Richmond Hill City of Richmond Hill Building Division
ZONING REVIEWED

ROUNDEL HOMES INC. (PH-2)

LOT No. 74

CURRENT DRIVE

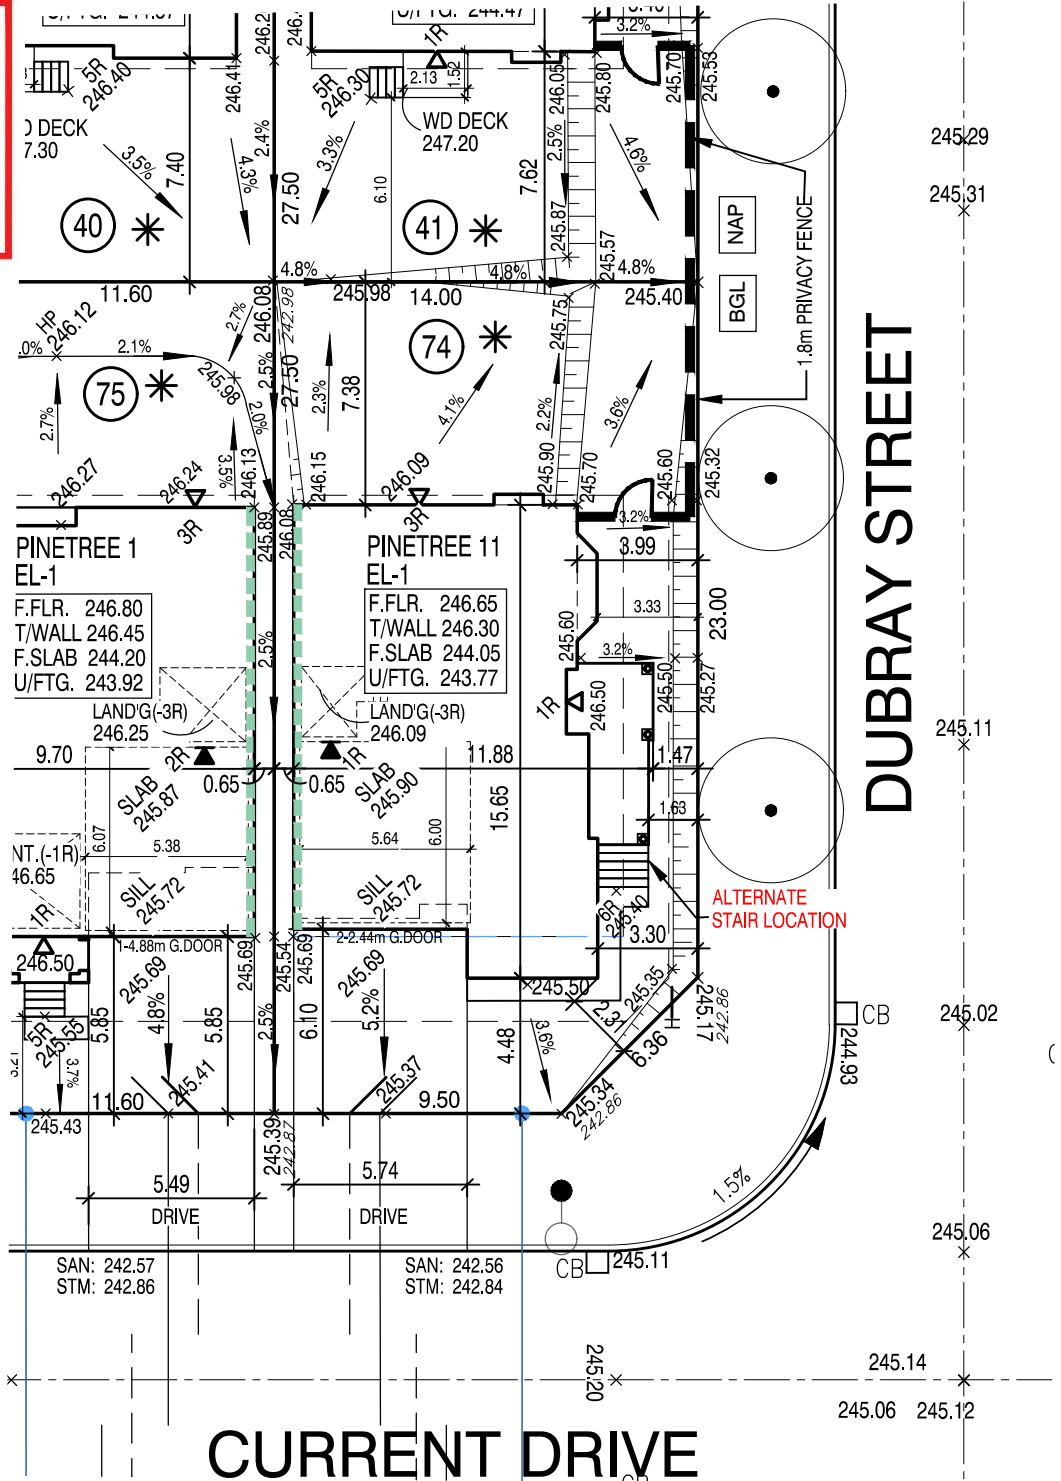
No unprotected openings permitted within 1.2 metres of the lot line as per 9.10.14 of the Ontario Building Code.

45 MINUTE RATED WALL
WITH SIDE YARD < 1.2m
